**NectarCAM**

# **Mechanical WP**

Progress Meeting / 2021-04-06

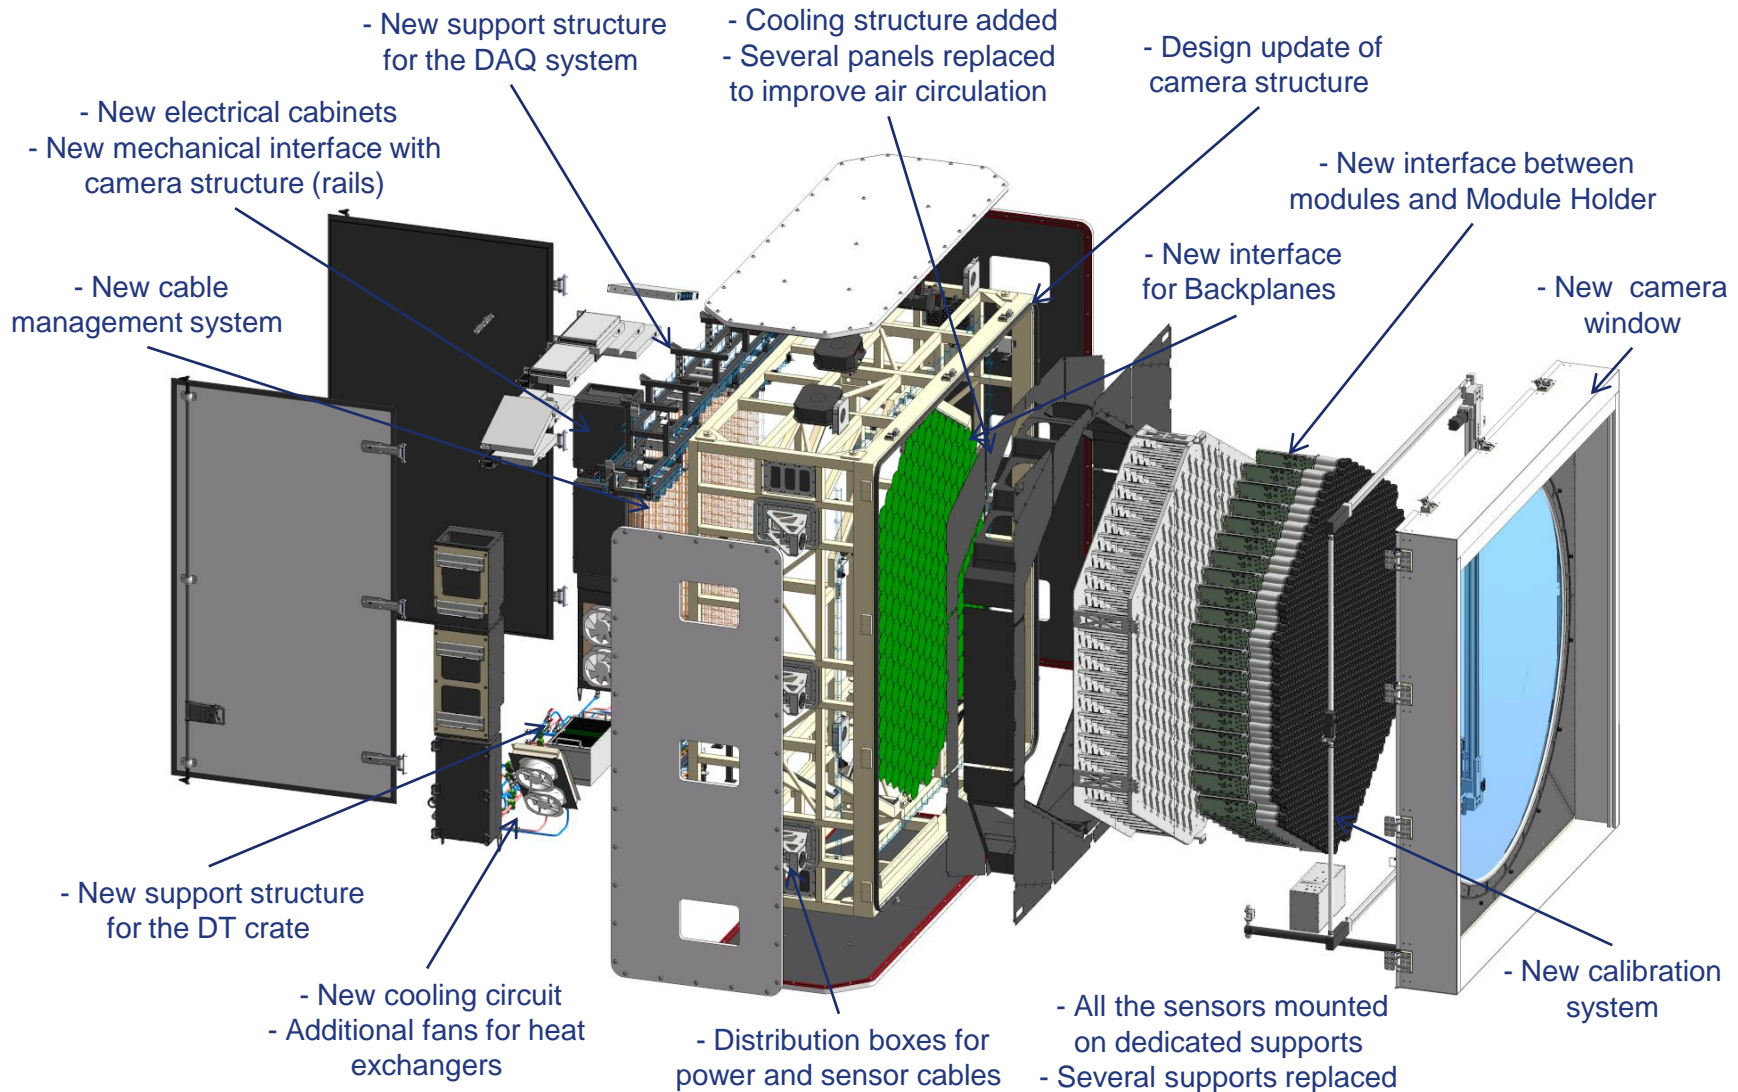
## ❖ **Incomplete / Missing interfaces in the ICD between the camera and the telescope**

- Alignment of the camera focal plane
- Tolerances on the position of the camera mounting holes
